D-PLCA Node Count Increase (Late Comment)

IEEE 802.3da - November 2025 Plenary – Bangkok, Thailand

Fig 148-8 – D-PLCA Control State Diagram (pg 86)

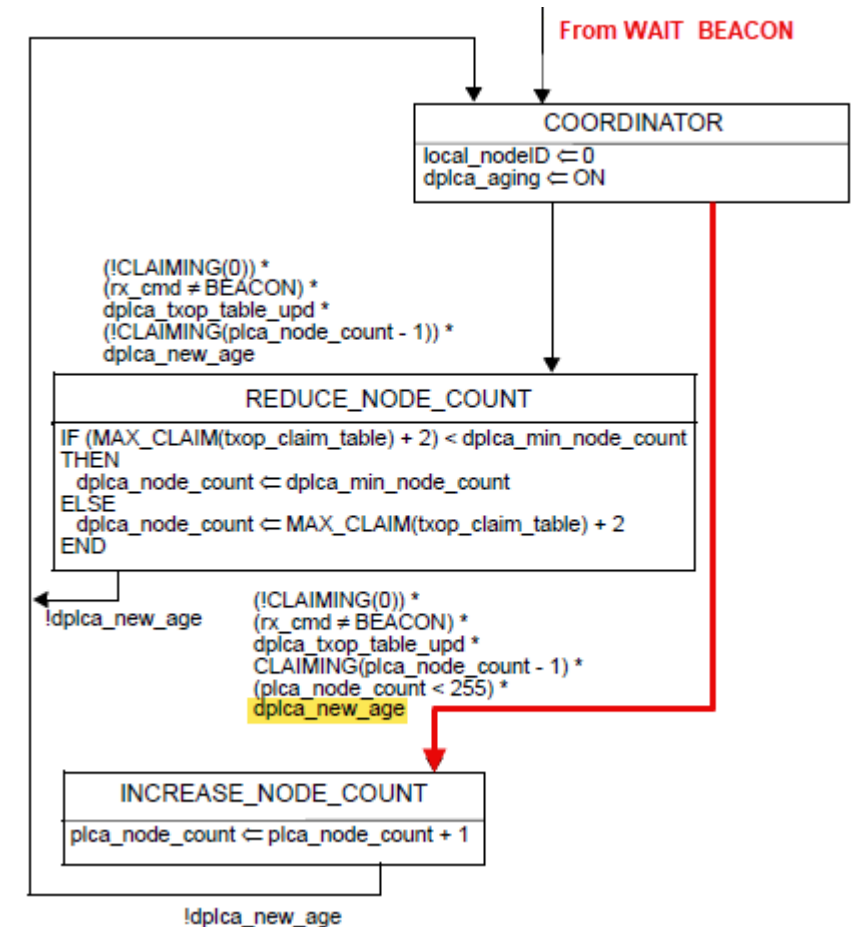
- The D-PLCA Coordinator only checks if the last TO of the cycle is claimed when:
 - The claim table is updated
 - $dplca_txop_table_upd == TRUE$
 - The aging period has elapsed and a new claim table made active with expired TO claims.
 - $dplca_new_age == TRUE$
 - Aging period defaults to 64 PLCA cycles (BEACONS)

Fig 148-8 – D-PLCA Control State Diagram (pg 86)

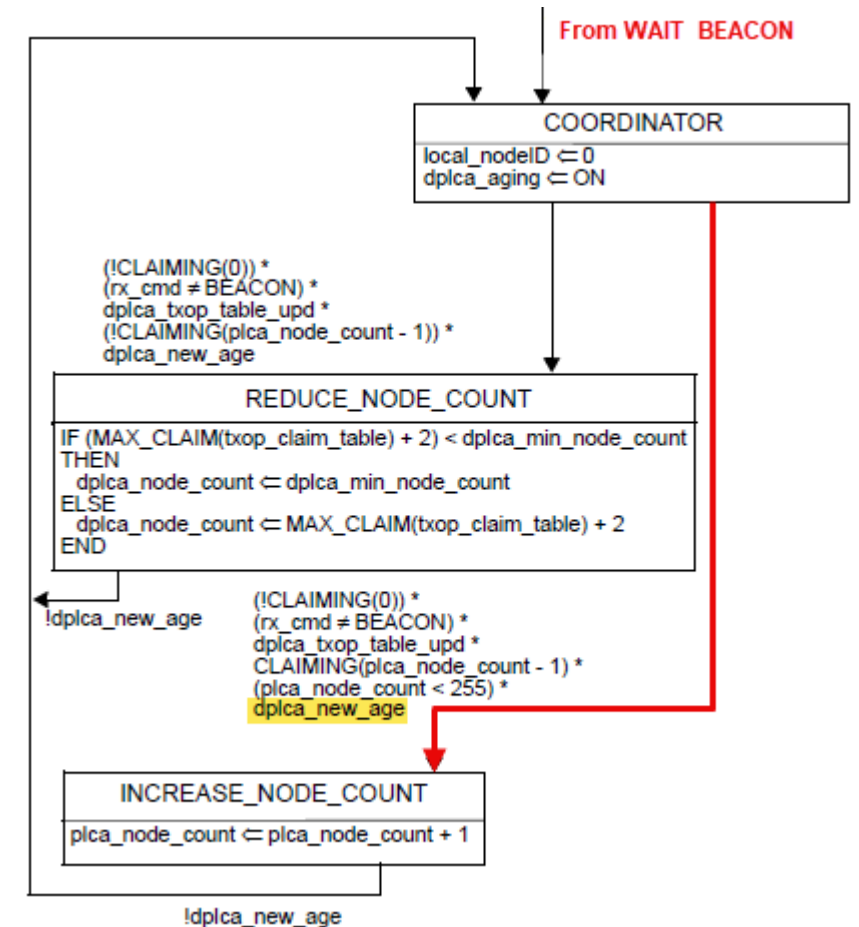
- The D-PLCA Coordinator only checks if the last TO of the cycle is claimed when:
 - The aging period has elapsed and a new claim table made active with expired TO claims.
 - `dplca_new_age == TRUE`
 - Aging period is 64 PLCA cycles (BEACONS)

Fig 148-8 – D-PLCA Control State Diagram (pg 86)

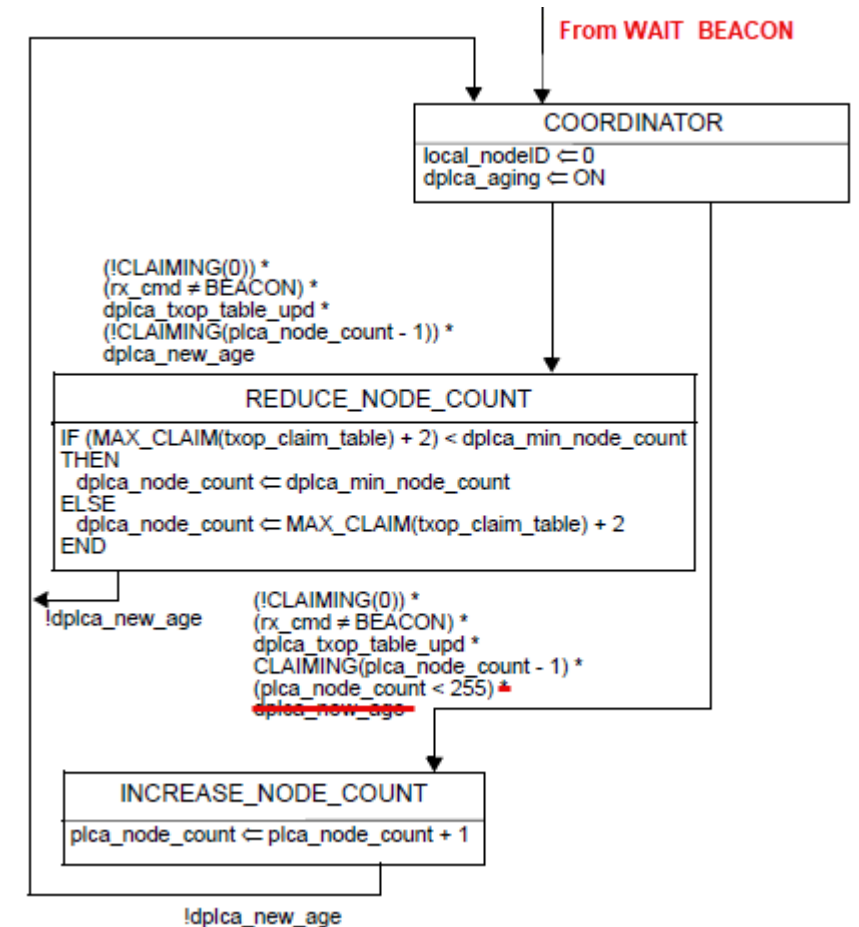
- **Eliminate the dependency on dplca_new_age when transitioning from COORDINATOR to INCREASE_NODE_COUNT**
 - Check the claim table to see if the last TO of the cycle is claimed following every update to the claim table
 - Allows the number of Transmit Opportunities per cycle to increase faster

Fig 148-8 – D-PLCA Control State Diagram (pg 86)

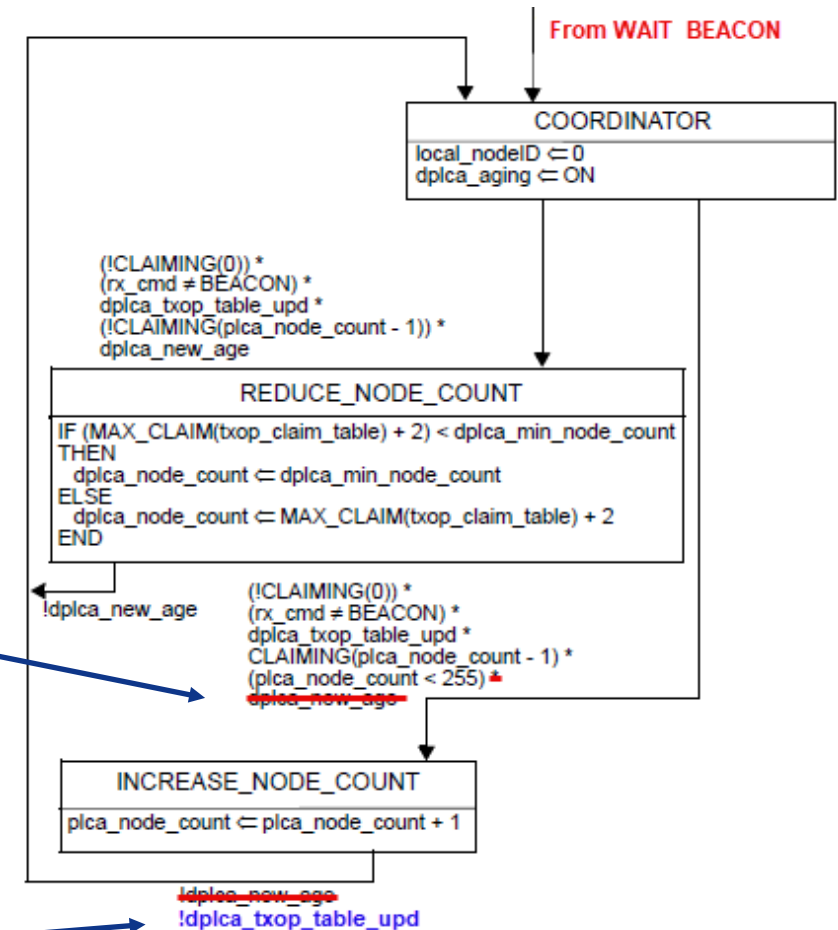
CI 148.4.7.5, Figure 148-8, Page 86, Line 33

Change the transition condition from COORDINATOR to INCREASE_NODE_COUNT as follows:

CI 148.4.7.5, Figure 148-8, Page 86, Line 43

Change the transition condition from INCREASE_NODE_COUNT to COORDINATOR from:

(!CLAIMING(0)) *
(rx_cmd ≠ BEACON) *
dplca_txop_table_upd *
CLAIMING(plca_node_count - 1) *
(plca_node_count < 255) *
~~dplca_new_age~~

~~!dplca_new_age~~

to:

!dplca_txop_table_upd
